EAST ANGLIA ONE NORTH

EAST ANGLIA TWO

Questions for the applicant in response to

SEAS (Suffolk Energy Action Solutions)

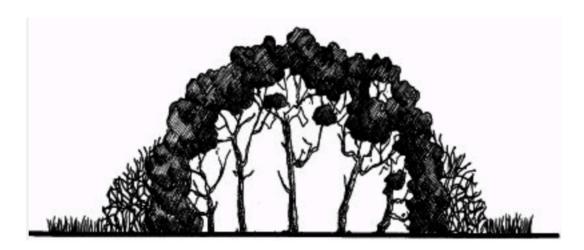
- 2.2.6 The applicant claims that Nightingale and Turtle Dove will survive the removal of habitat required by cable laying in one season. They add that the birds' habitat comprises scrubland with established shrubs, bramble and grasses but a significant proportion of these will be removed. The British Trust for Ornithology's research suggests that the optimal habitat includes particular ages of coppiced woodland and a well-defined structure of scrubby thicket in which to set up their territories. Removing and opening up scrubland, as the cable-laying will do, will make the landscape too open for the secretive bird. It will take some years to restore scrub, and even longer to achieve anything like a canopy, as in the BTO's suggested and successful mitigation diagram below.(18)

2.2.7 Turtle Dove is Britain's fastest declining species. In the UK, Turtle Doves usually nest in tall, dense mature scrub or hedgerows, especially if they contain standard trees, thorny shrubs, tall hedgerow shrubs and climbers. Dense, thorny vegetation provides the birds with a safe place to build their nest. Good Turtle Dove
